USD 321 Rossville High School Addition and CTE Renovation – JGR Proj #22-3269

ADDENDUM NO. 3

Sheet 08 – Civil Utility Plan Sheet A1.0 – Site Plan

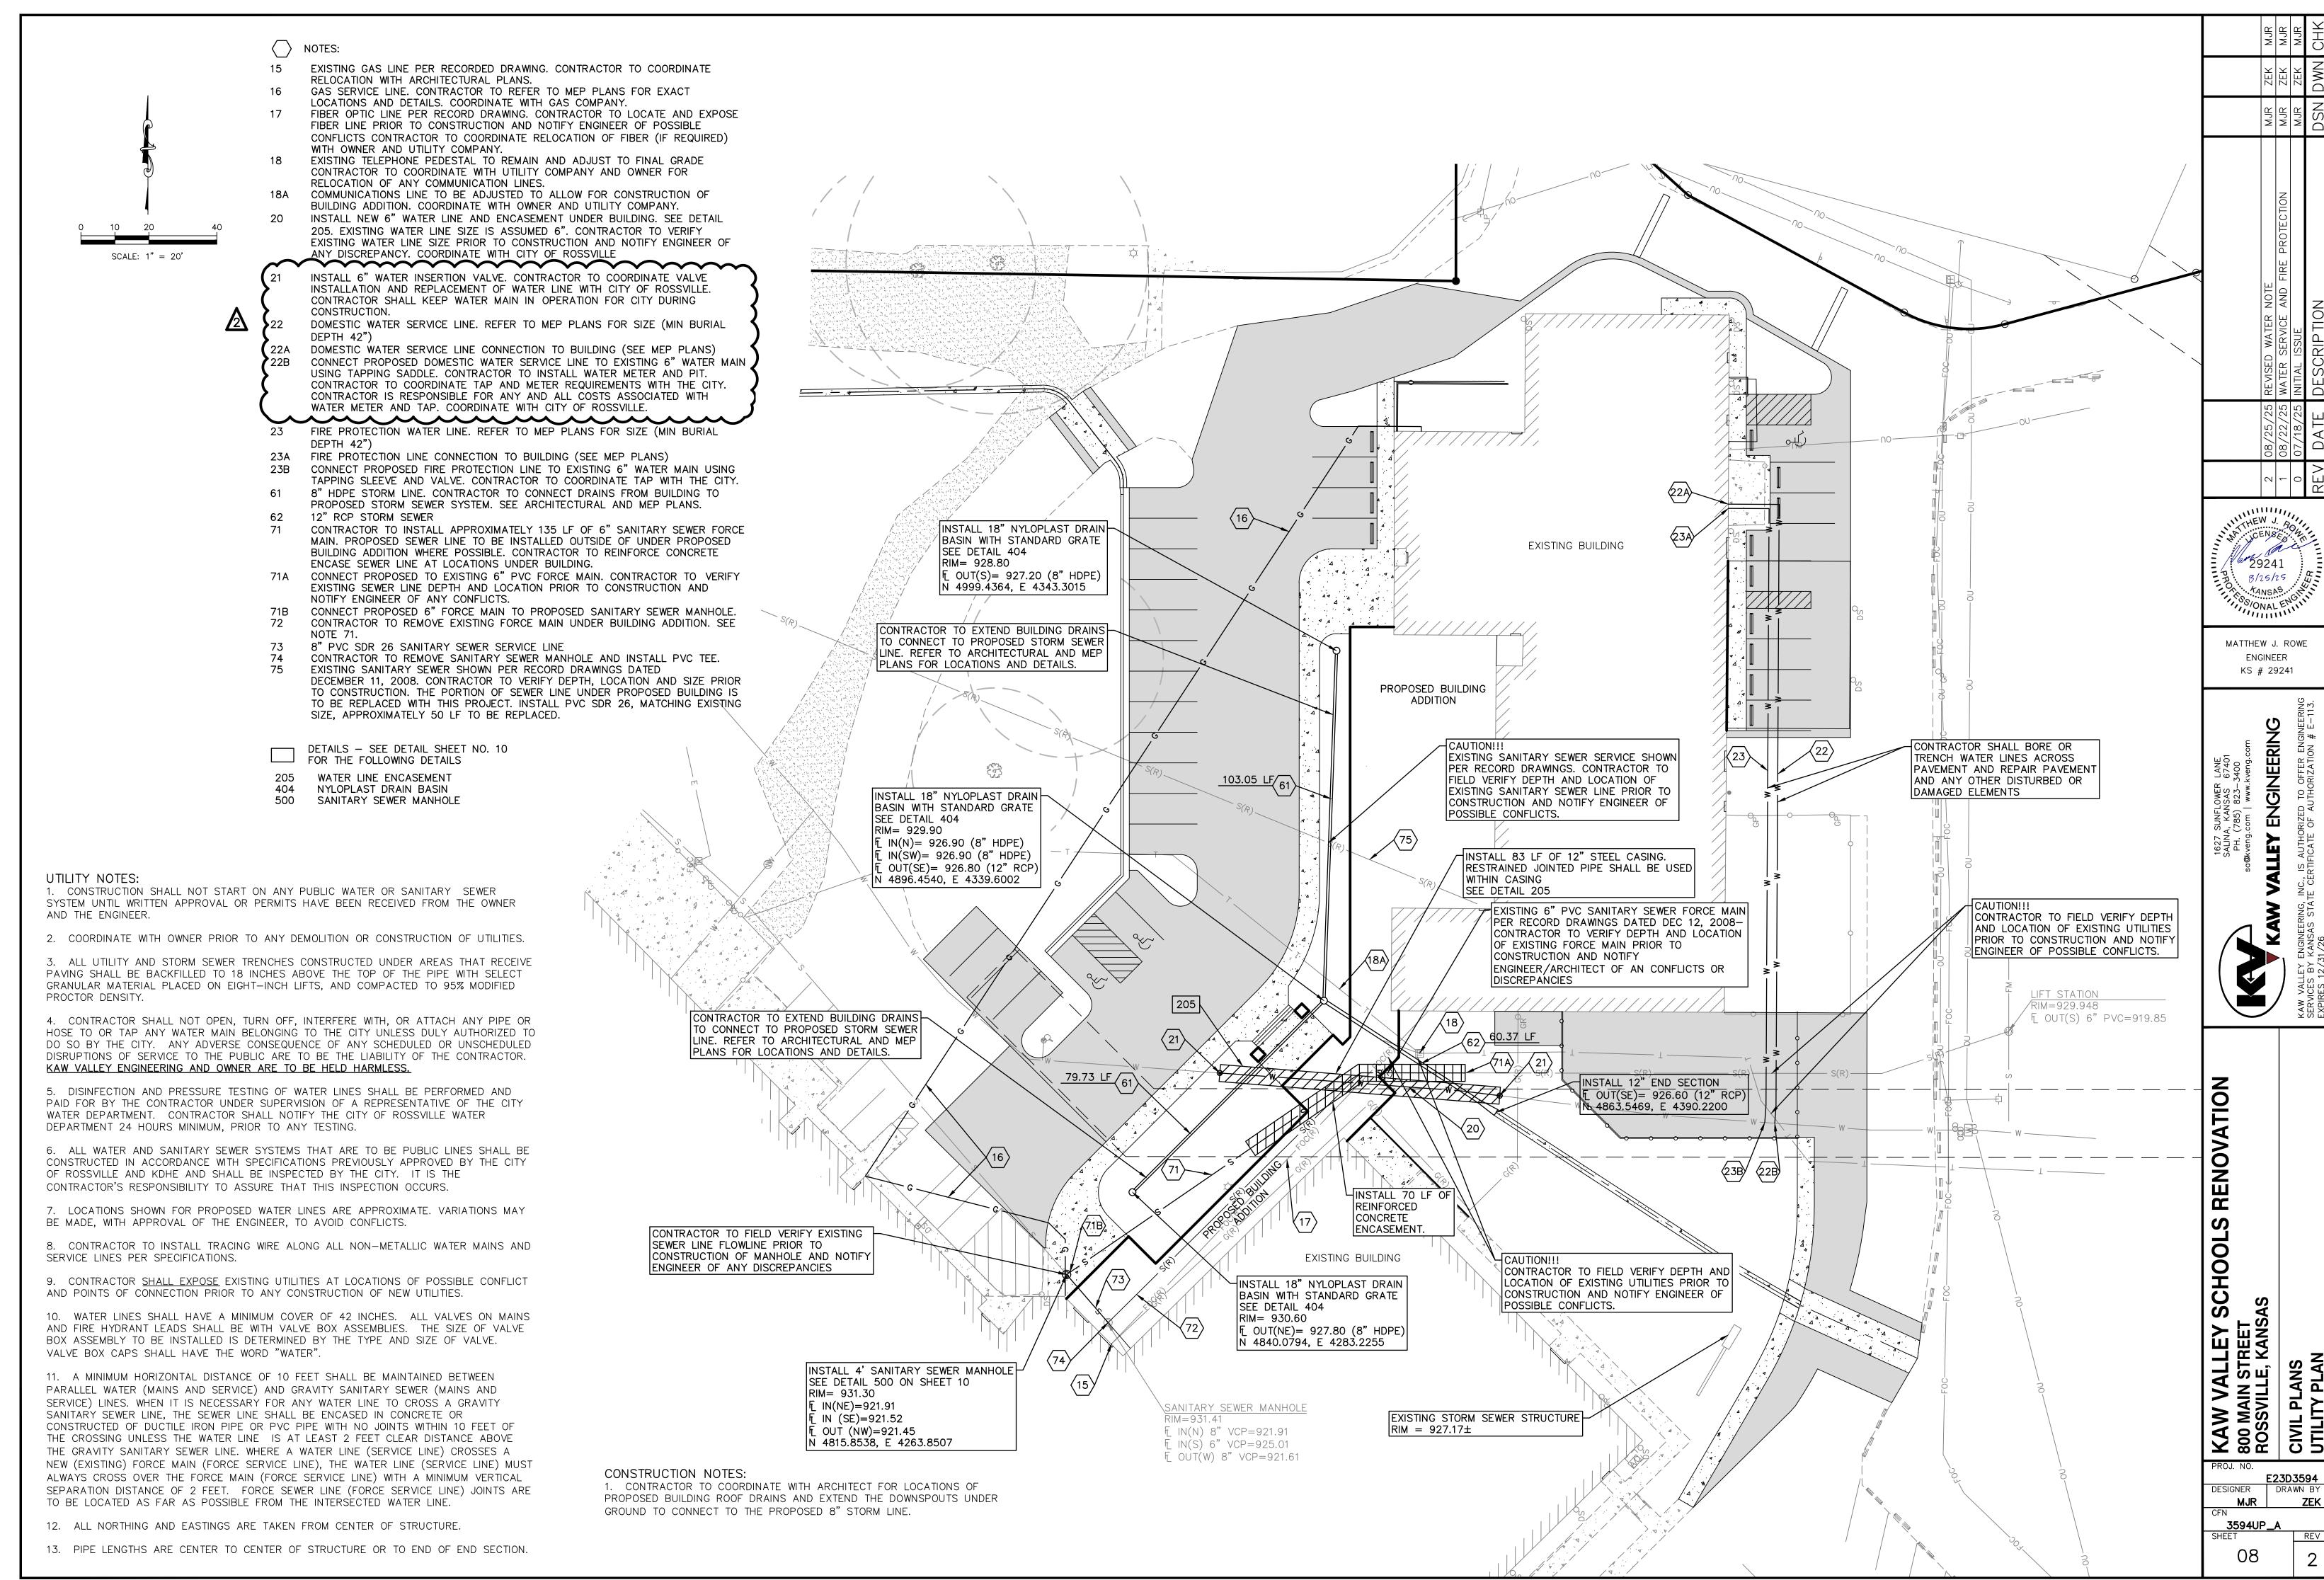
1. Sheet 08 Utility Plan - Reference the attached revised sheet 08. Plan note 21 has been updated to specify the installation of an insertion valve in lieu of a hot tap.

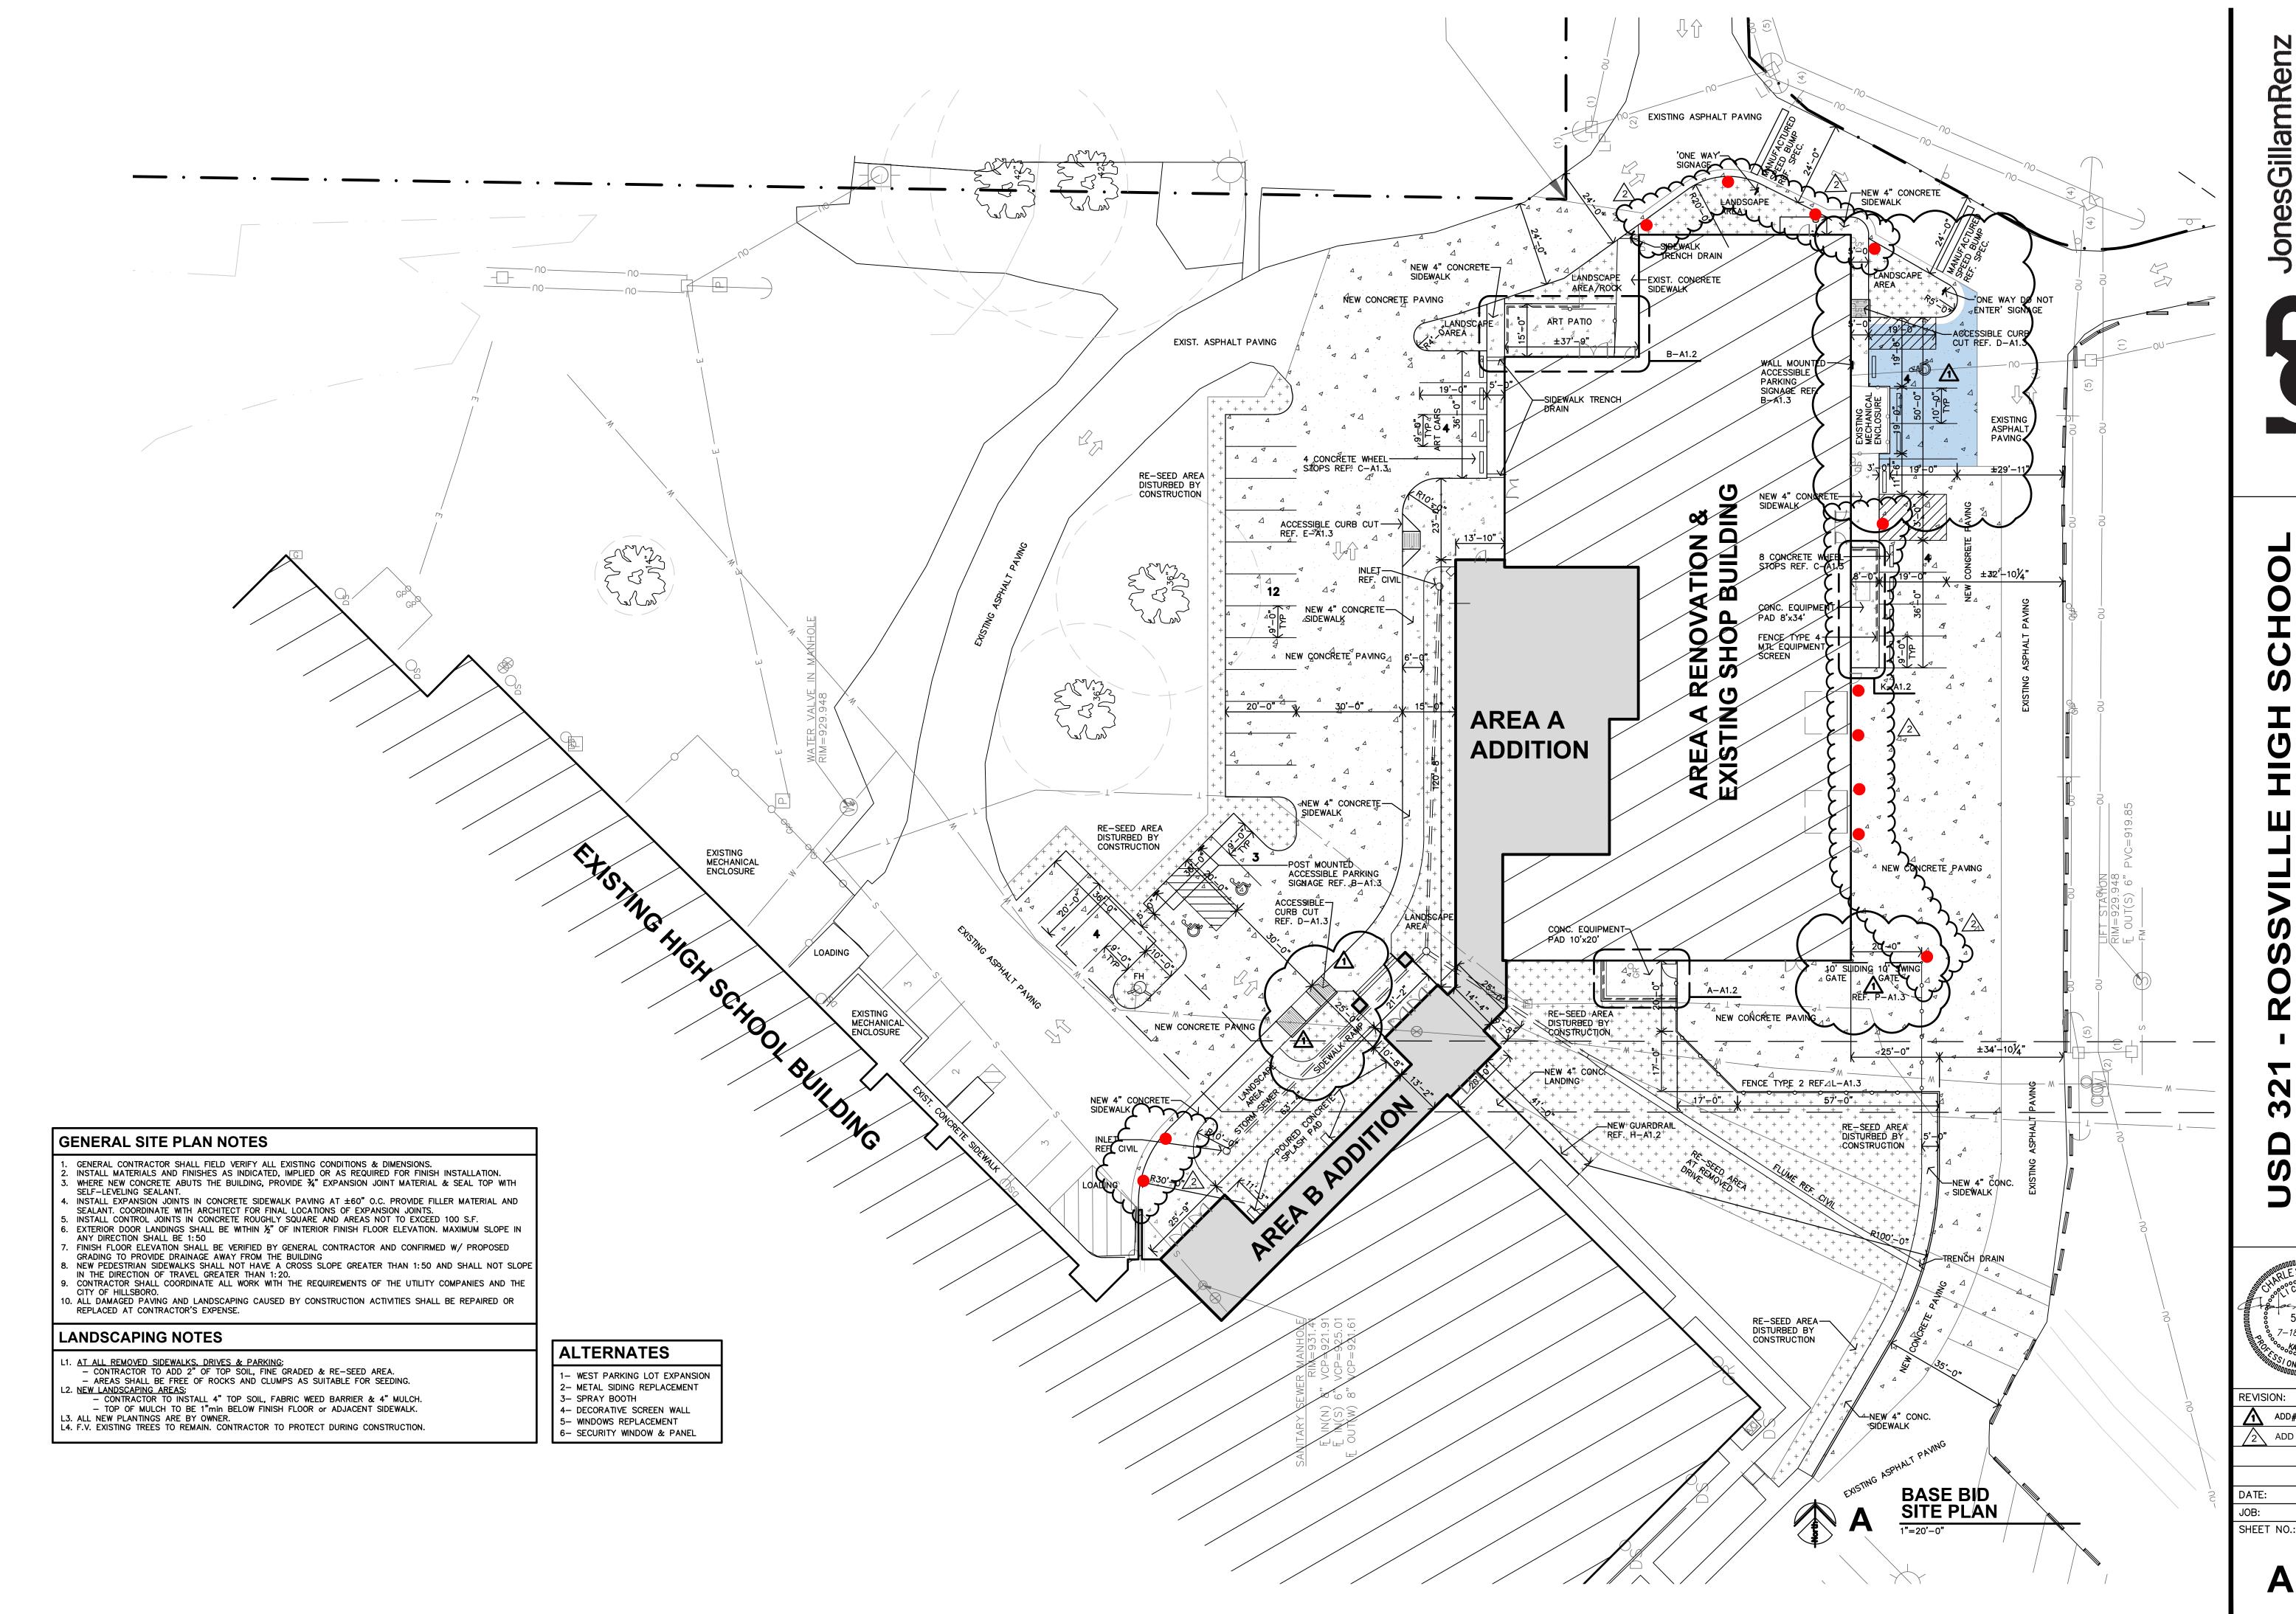
- Code Footprint Code Information Building 3 Clarification The automatic fire suppression system is new. Reference MEP and Civil for the service line connection, riser, and panel locations.
- 2. Sheet A1.0 Site Plan Revised Sheet identifies location for 12 bollards. Bollards to be 4" steel pipe per specifications, filled with concrete.
- 3. Sheet A10.1 Interior Finish Schedule Hall 138 is to be walk-off carpet.
